JUSTIFICATION

REMOVAL OF INTERNAL CASEMENT WINDOWS

107 HIGH STREET, LINDFIELD, HAYWARDS HEATH, RH16 2HR

3. Approved first floor plan - submitted drawings under application DM/22/3694 & DM/22/3695 (planning approved)

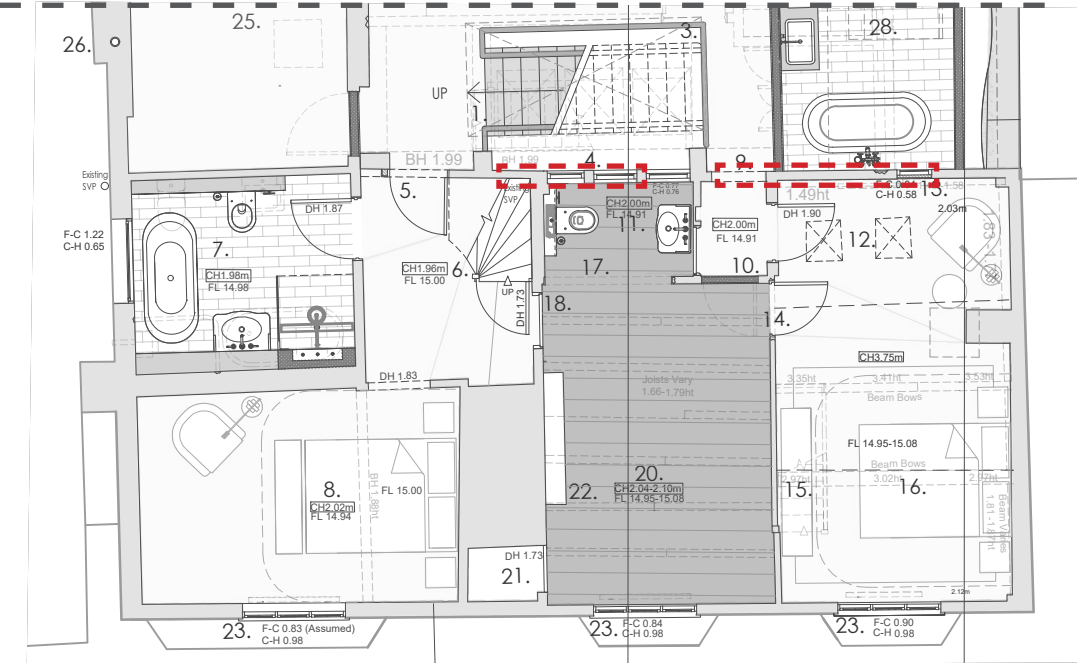
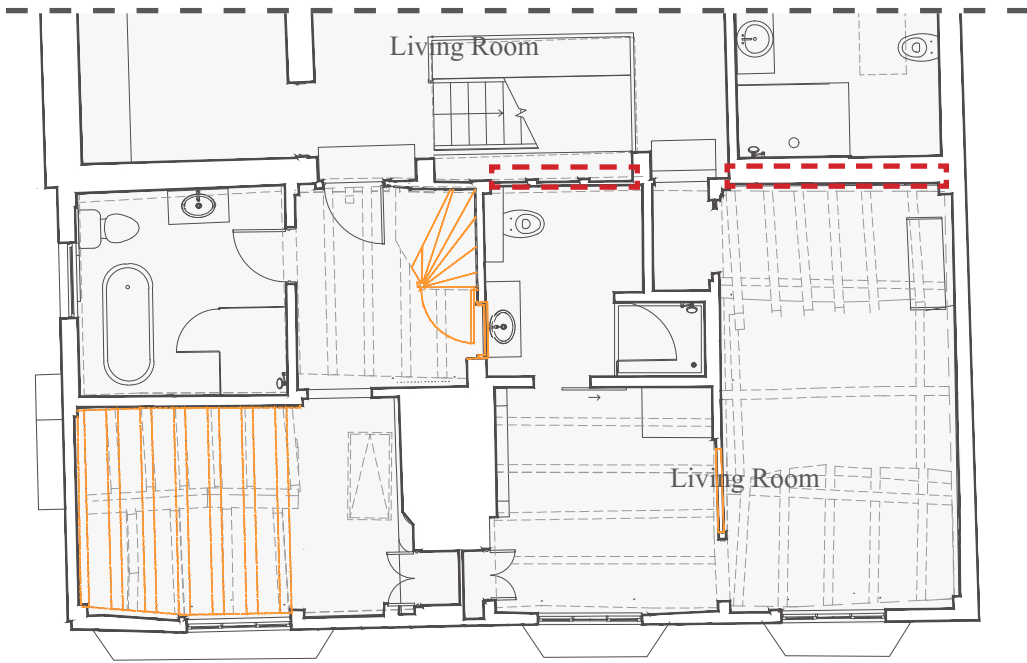
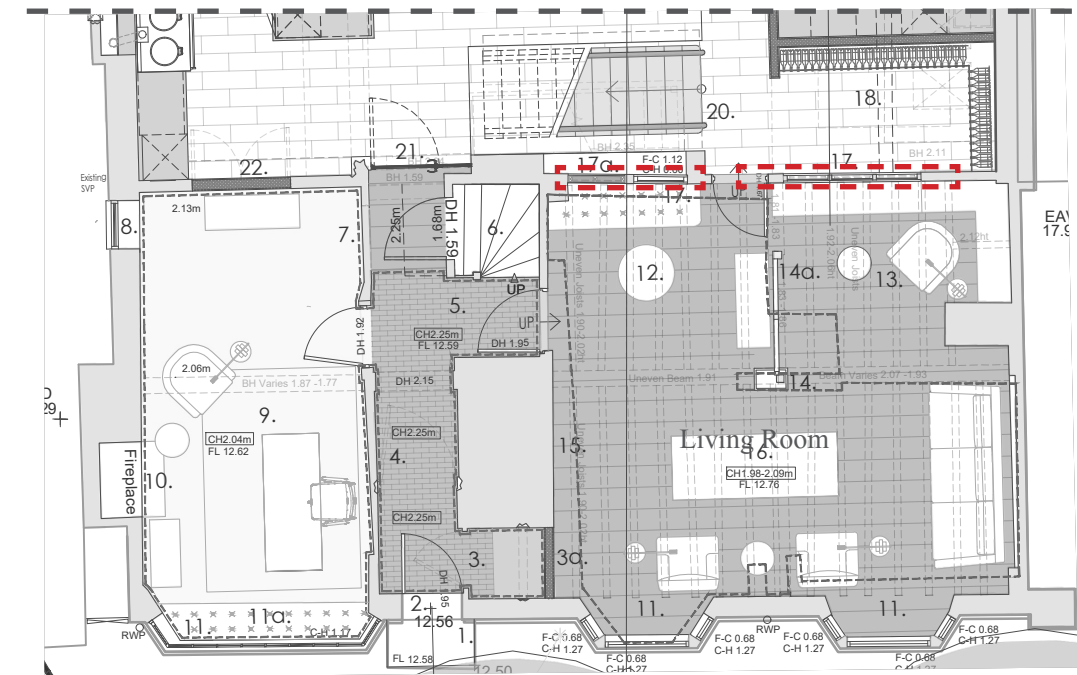
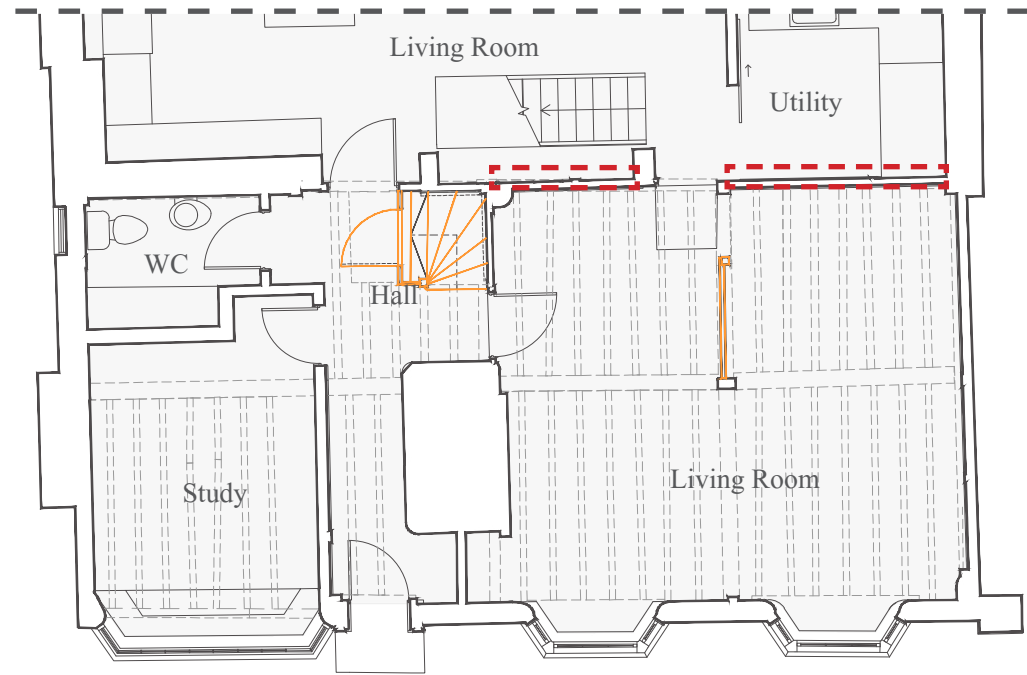
The casement windows to the west facade of the listed building have been removed and openings filled in, deviating from the approved scheme proposing their retention.

The windows were not original, added in 1990s and poorly detailed. After their removal the openings have been infilled with traditional fibrous wood wool boards faced in lime plaster. This change reveals and expressed the 15th century timber framing, which has been carefully repaired and renovated, which according to the supporting HCUK report is a significant heritage benefit.

Drawing GH342 PL02 Rev B approved drawings under application DM/22/3694 & DM/22/3695

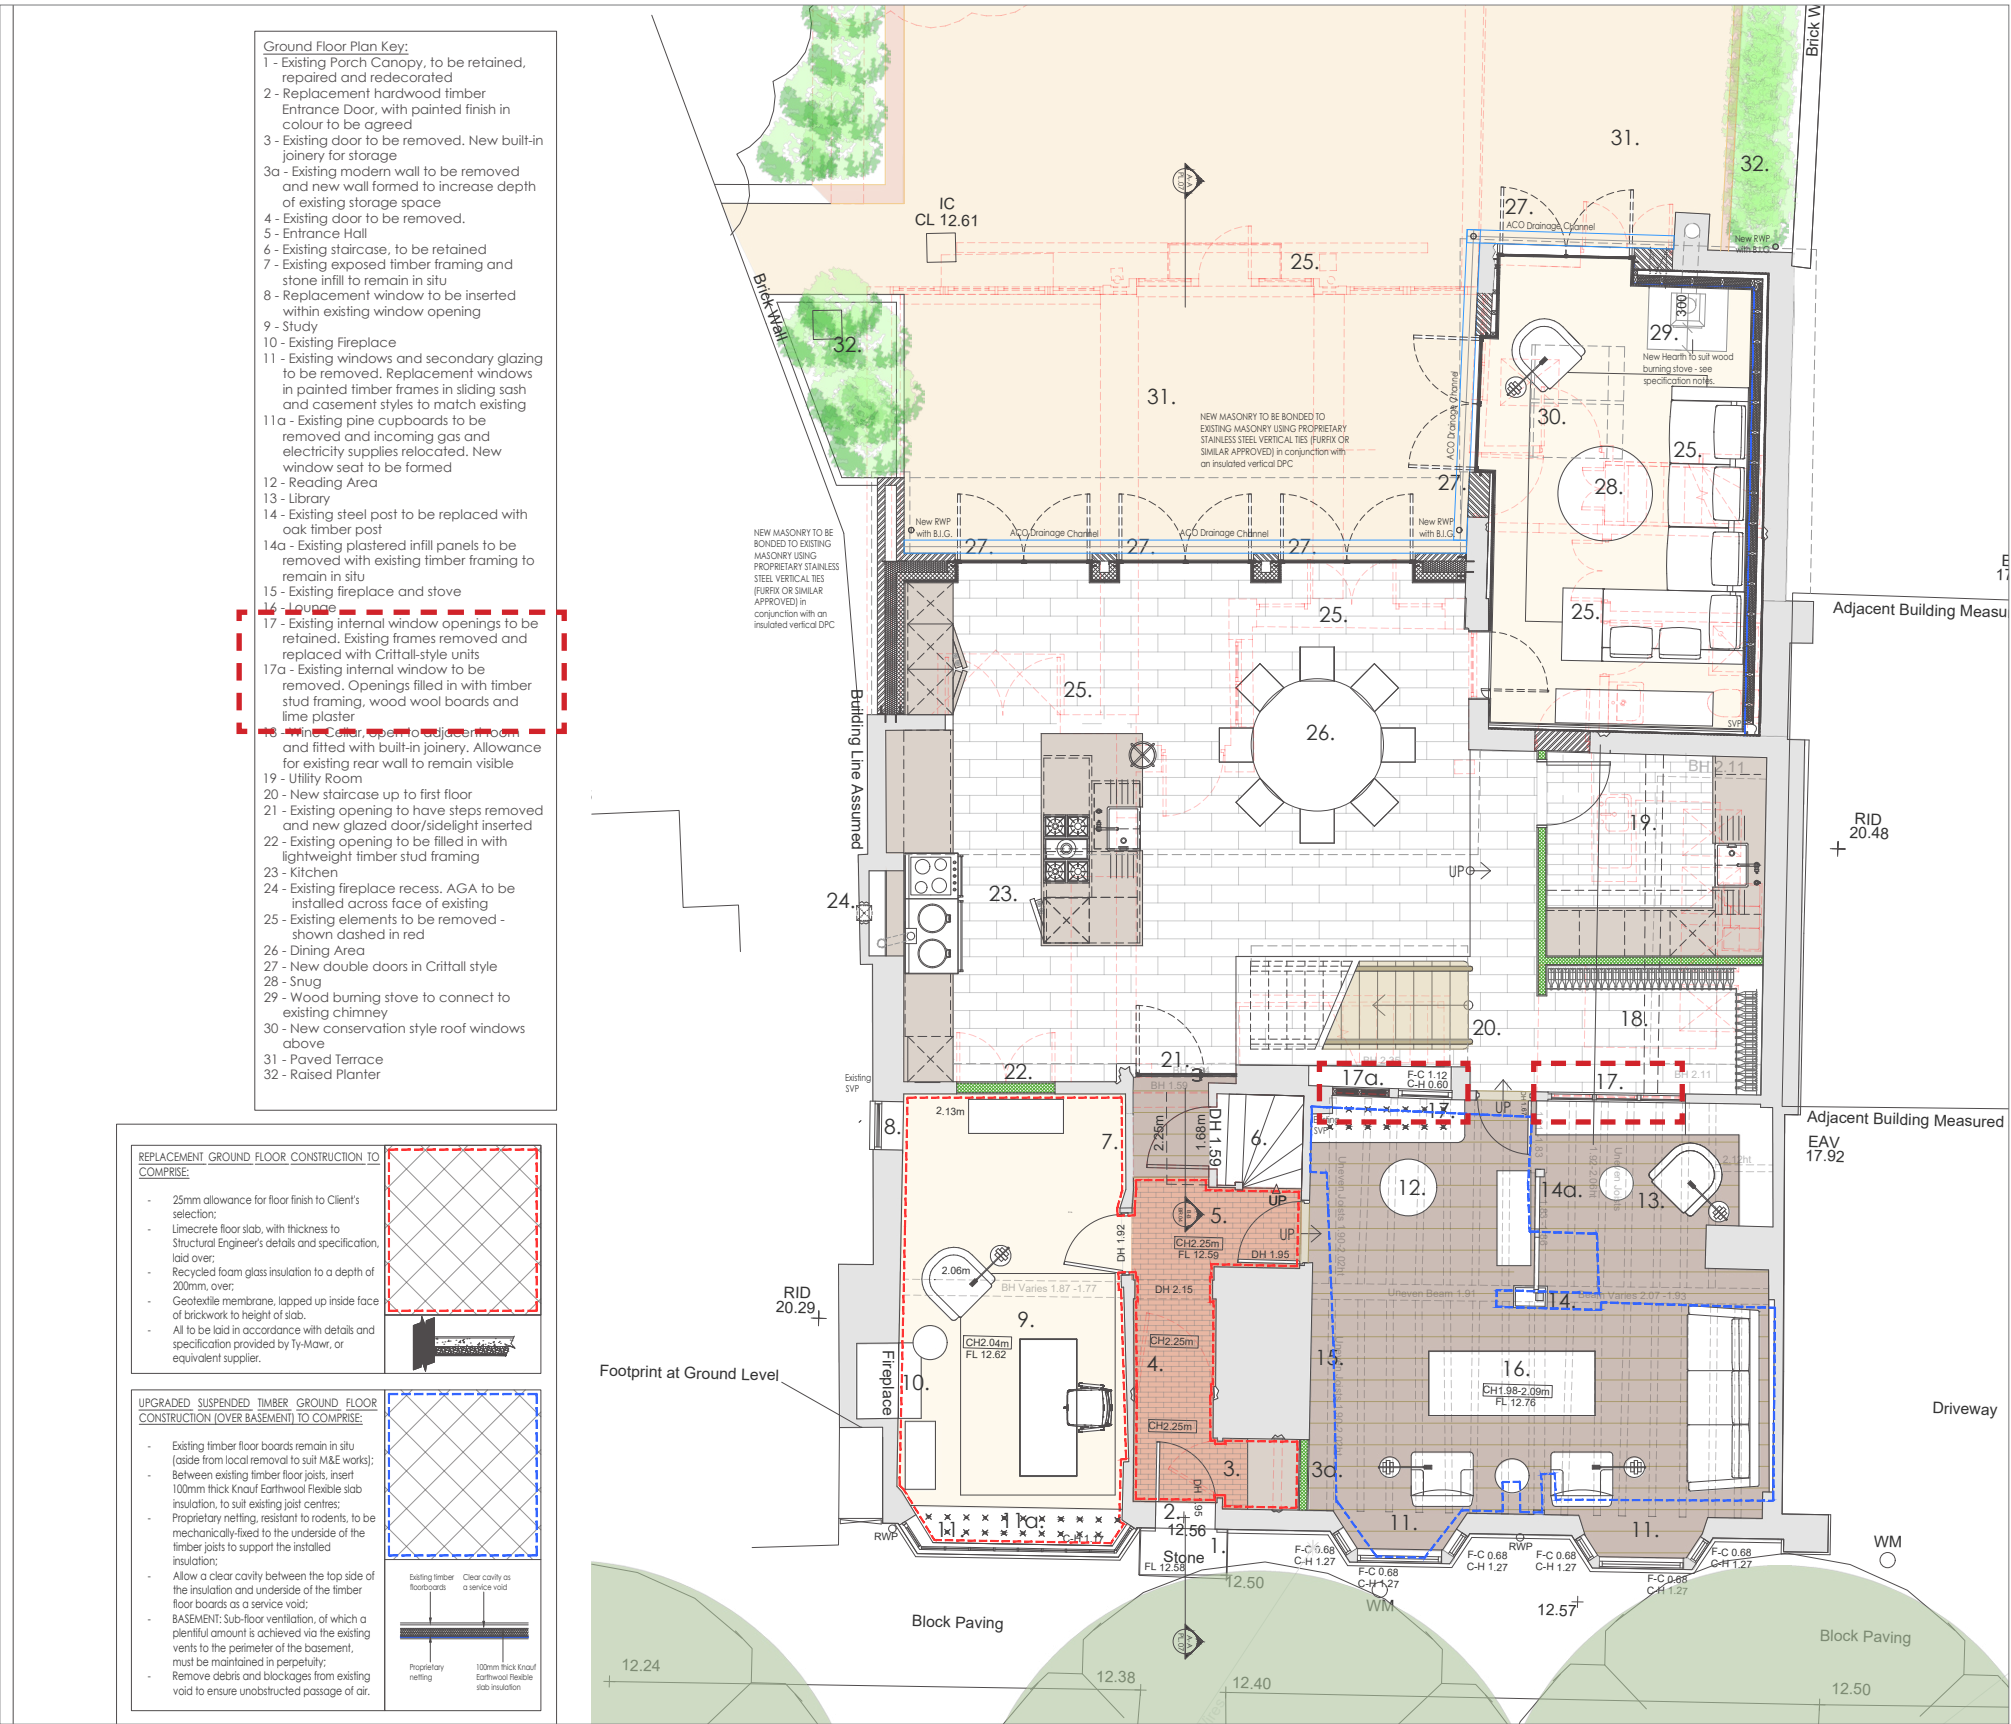
Point 17 of the approved drawing GH342 PL02 Rev B confirms removal of existing casement windows.

Point 17a, relating to the internal opening adjacent to the corkscrew staircase, confirms filling in of the opening with timber stud framing, wood wool boards and lime plaster.

‘17 - Existing internal window openings to be retained. Existing frames removed and replaced with Crittall-style units
17a - Existing internal window to be removed. Openings filled in with timber stud framing, wood wool boards and lime plaster.’
